# TECHNICAL NOTE Edition Anglaise

RENAULT Twingo

This note cancels and replaces Technical Note No. 2294A

## POSITION OF ENGINE MOUNTINGS

# Front RH engine mounting without air conditioning

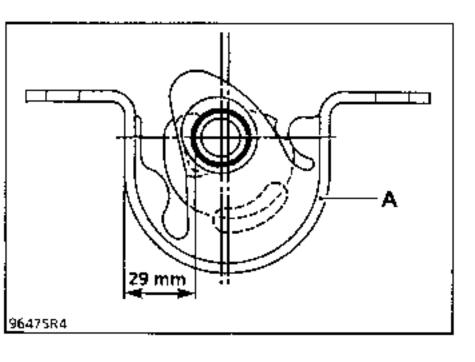
In this Technical Note you will find the dimensions for positioning the engine mountings. (The dimension of the front right-hand engine mounting for the version with air conditioning is different.).

In order to check that the engine and gearbox assembly is correctly positioned, measure the dimensions indicated below (with the engine only supported by the engine supports).

If these dimensions are not correct (28  $\pm$  1 mm or 29  $\pm$  1 mm or 42  $\pm$  1 mm for the version with air conditioning) mark the actual position on the side member.

If the dimension is less than the nominal dimension minus 1 mm, loosen the front support in question and push on section (A) to move it back. Retighten. Check the measurement again and repeat the operation if necessary.

If the dimension is more than the nominal dimension plus 1 mm, carry out the same operation but move section (A) forwards.

### Front RH engine mounting with air conditioning

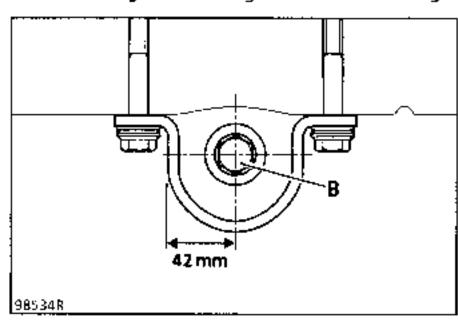
For the version with air conditioning the dimension to be checked changes because screw (B) is present. It is now 42  $\pm$  1 mm.

### Front LH engine mounting, all types

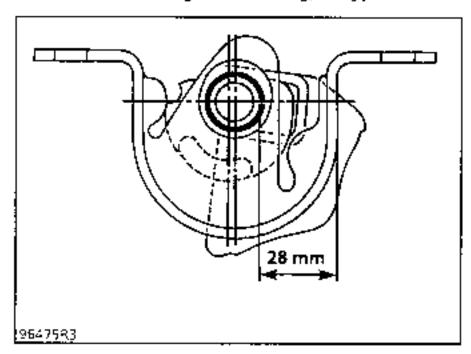
Then tighten the 4 bolts to the recommended torque ensuring that parts (A) are not moved during the tightening operation and that they remain parallel to the vertical face of the side member.
